Hocutt-Ellington Library Renovation

Bid # 700-ENG-2025-12

Addendum No. 03

**A610**

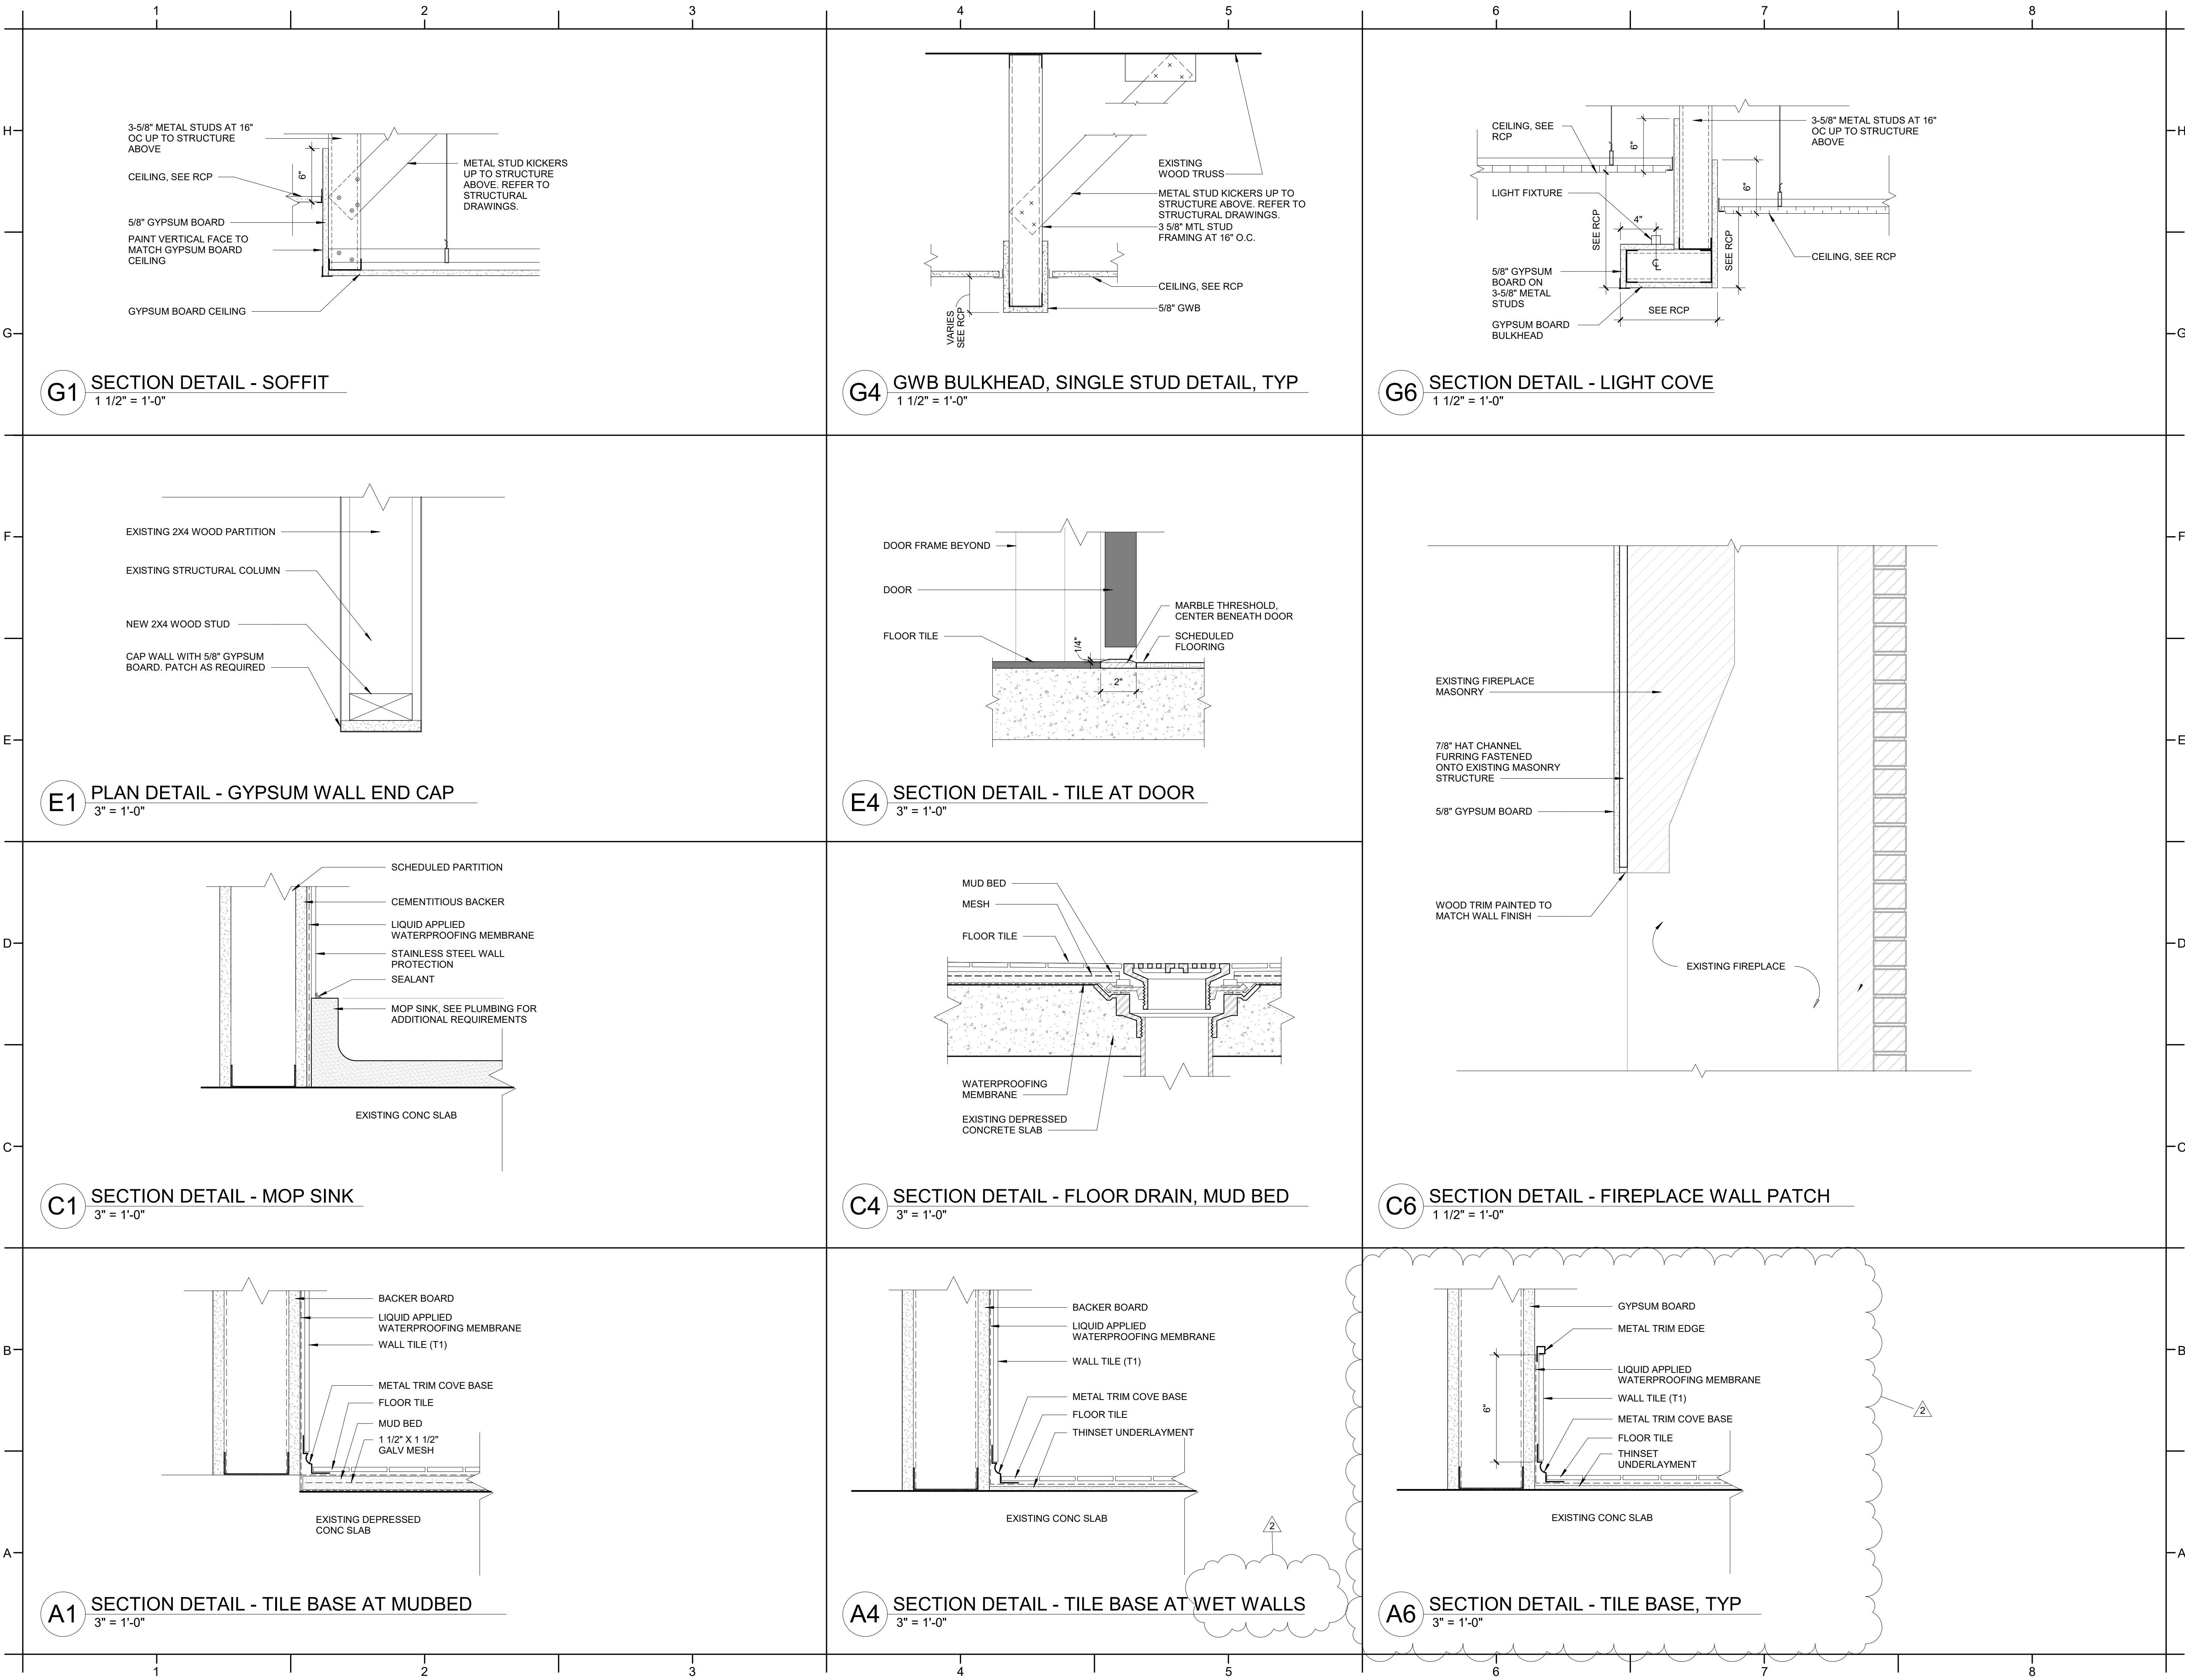
1. Sheet A610
  - a. Added detail A6 to indicate the floor base treatment in restrooms for walls that do not have tile.
